SP AUSNET REVENUE RESET

An independent review

<i>Document Reference:</i>	SPA2008Reset_v6_0.doc
<i>Report Revision :</i>	6_0
<i>Report Status :</i>	Final
<i>Prepared by :</i>	<hr/>
	C Brennan, V Petrovski, J Thompson, M Walbank, P Walshe, P Williams
<i>Reviewed by :</i>	<hr/> P Williams
<i>Approved by :</i>	<hr/>
	P Williams
<i>Date Issued :</i>	16 August 2007

Figure 5-13 – S-curve for purchase and install replacement 220 kV CTs

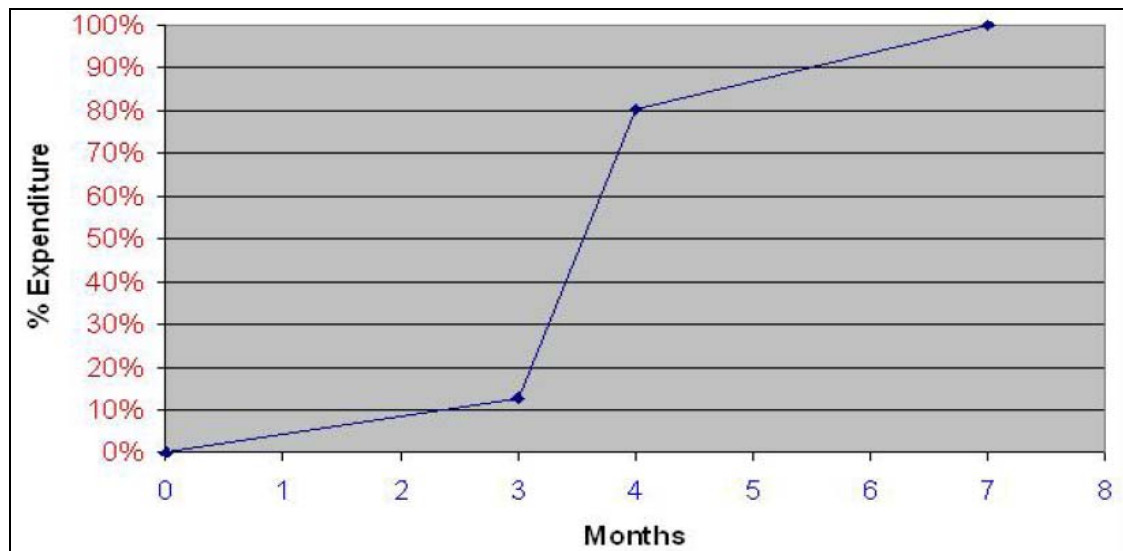
Figure 5-13 relates the replacement of 220 kV CTs, and proposes that such projects typically require 7 months to complete. This overall timeframe does not seem unreasonable given the supply lead time of CTs¹²¹; however, the 3-month installation timeframe does seem slightly higher than would have been anticipated from PB's experience, given that design and job scheduling can occur during the equipment lead time. Nonetheless, PB is of the view that this expenditure profile is reasonable.

Figure 5-15 – S-curve for station rebuild > \$25m

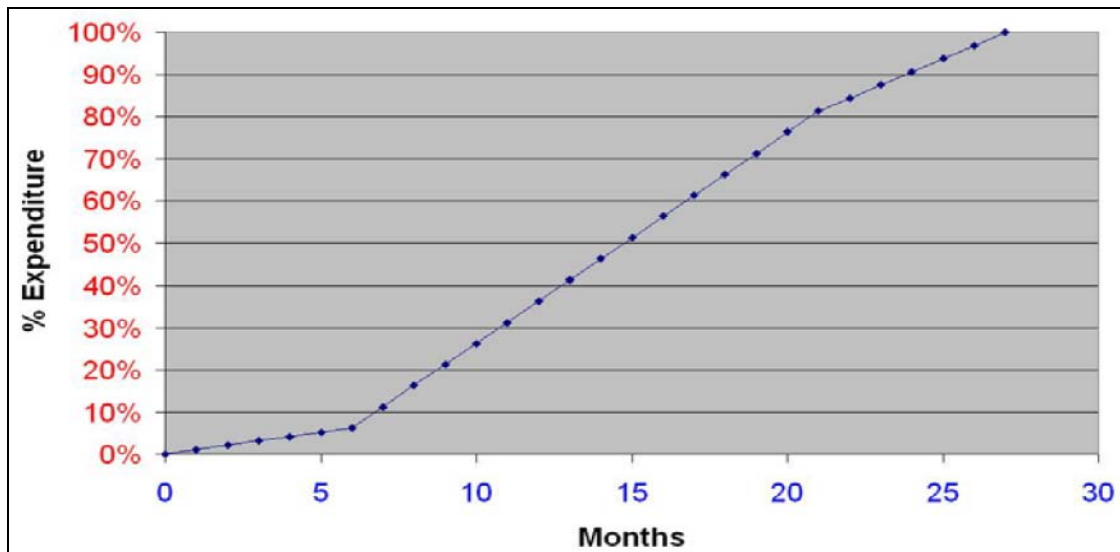
Figure 5-15 relates the rebuild to terminal stations for large projects (over \$25m) and proposes that such projects take approximately 27 months to complete. SPA has also supplied¹²² a second version of this S-curve, as shown in. This updated version (curve 2) suggests a 33-month implementation timeframe. Direct comparison of Figure 5-16 and Figure 5-15 shows that this timing difference implies an additional 27% (37%–10%) of the project expenditure will have been incurred (theoretically) at the 12-month point. While at 24 months this additional expenditure would account for an additional 22% (90%–68%). Essentially the use of the originally documented curve advances the project cash flow by around 20%–25% in simple terms.

Figure 5-18 shows a comparison of the three S-curves each rescaled to a 28-month implementation timeframe. It is clear from this comparison that SPA’s original S-curve (Figure 5-15) overstates the cumulative project expenditure at the 12-month point by approximately 20% (38%–18%) in comparison to the results of the PB analysis, and by 26% (38%–12%) in comparison to the version 2 curve submitted by SPA (Figure 5-16)¹²⁵.

Figure 5-16 – Version 2 of S-curve for station rebuild > \$25m

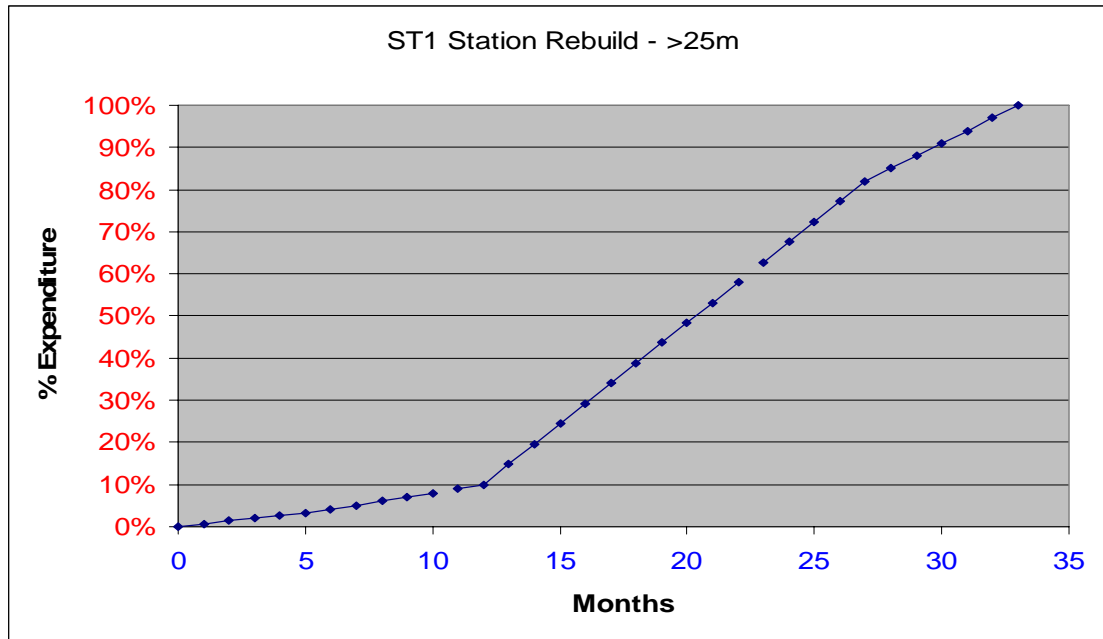
Notwithstanding this ambiguity, we have some evidence (the RTS expenditure profile) that SPA has used an S-curve (the second version, Figure 5-16) that benchmarks well against publicly available material and our internal references. On this basis, we do not propose to adjust SPA's 'as spent' expenditure profiles. Prior to the AER accepting SPA's expenditure profiles, we recommend that SPA provides further assurances on the actual S-curves it has adopted and applied and how it arrived at these curves.

Figure 5-17 – Station rebuild S-curve derived from SPA ex-post data

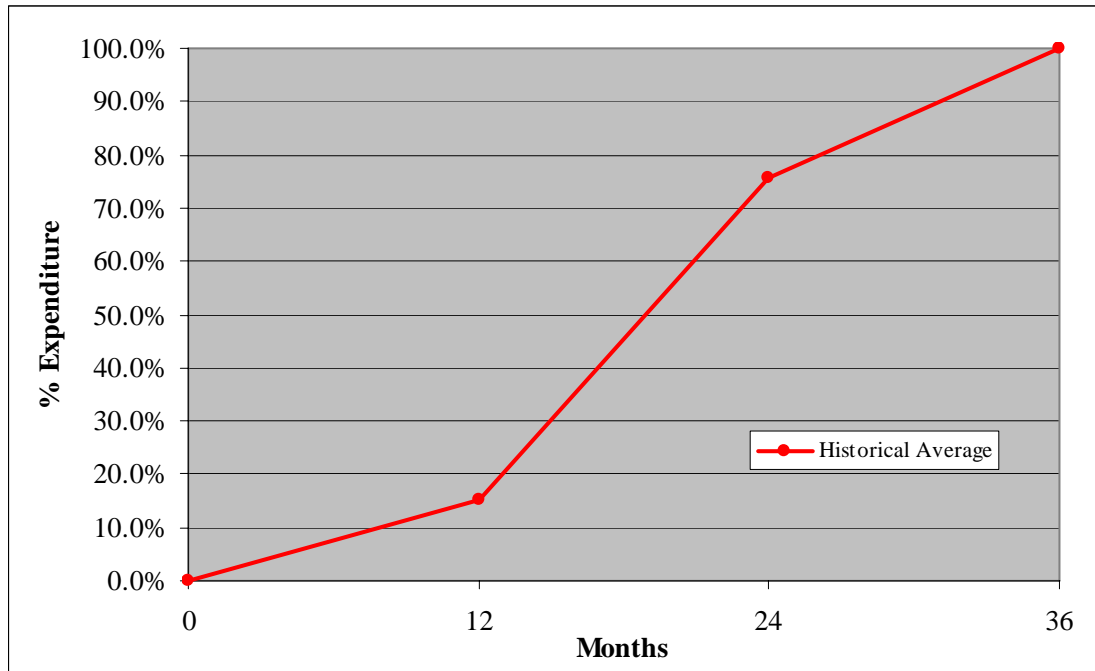
Figure 5-17 shows the S-curve PB derived from analysis of the SPA submitted station rebuild data¹²³. This analysis was based on a 36-month implementation timeframe as the supplied data was annualised. The analysis shows that at the 12 month and 24 month points the cumulative project expenditure would be approximately 16% and 75% respectively.

Figure 6-11 – Age and recorded kilometres at time of sale, for vehicles used in the transmission business

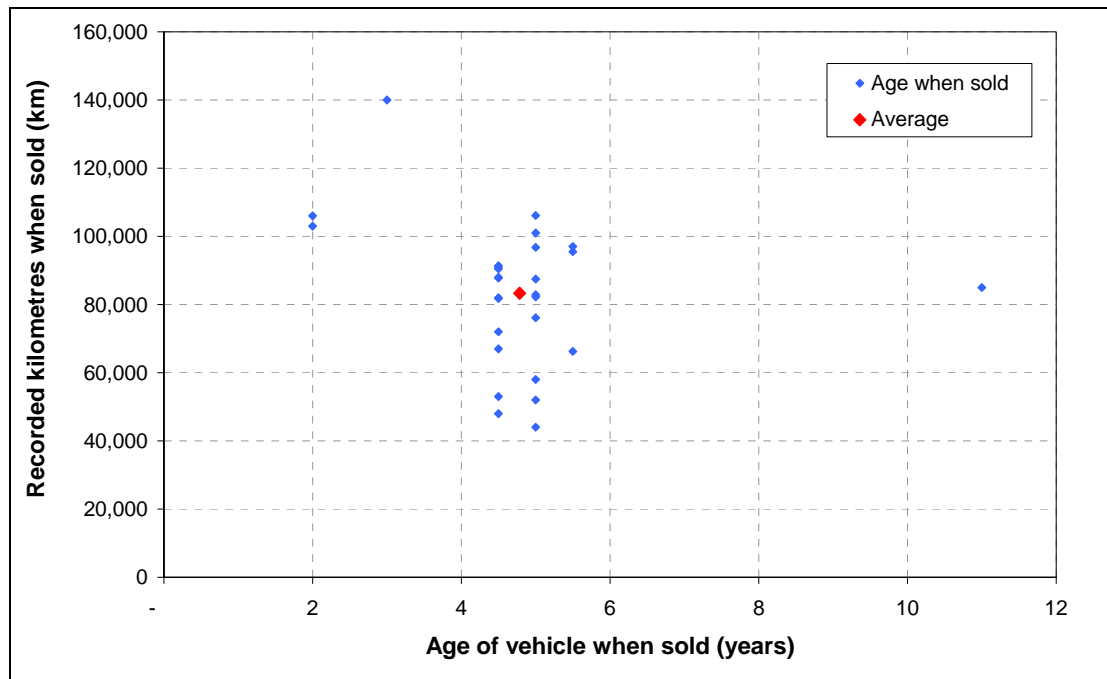
PB has identified that the average age, against average kilometres, for the 36 vehicles is 5 years or 80,000 km; this is shown as the red data point on Figure 6-11.

Figure 7-3 – BTS-RTS 220 kV cable earth sheath insulation resistance readings

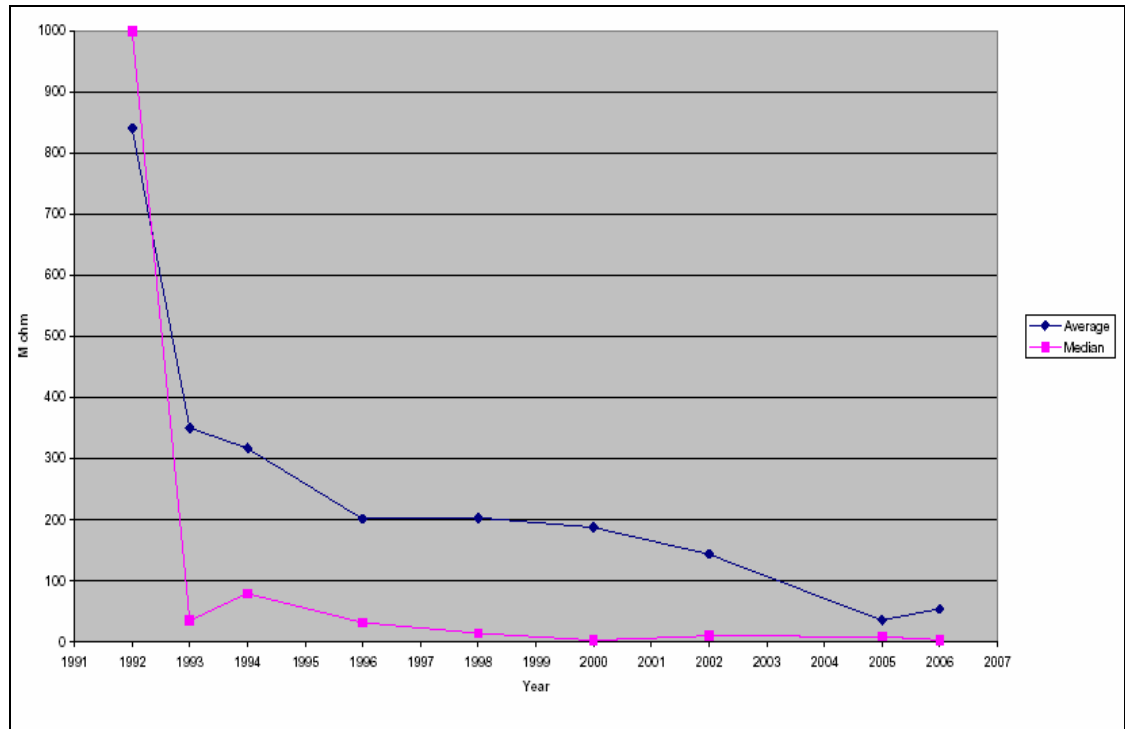
As part of its review, PB also requested records of the cable earth sheath readings. The results of this request are given in Figure 7-3. This data confirms the progressive ingress of moisture into the joints and is the most compelling evidence justifying the commencement of a comprehensive joint replacement program. PB notes that the median readings are not registering on the chart and should be in the hundreds of M ohms range.
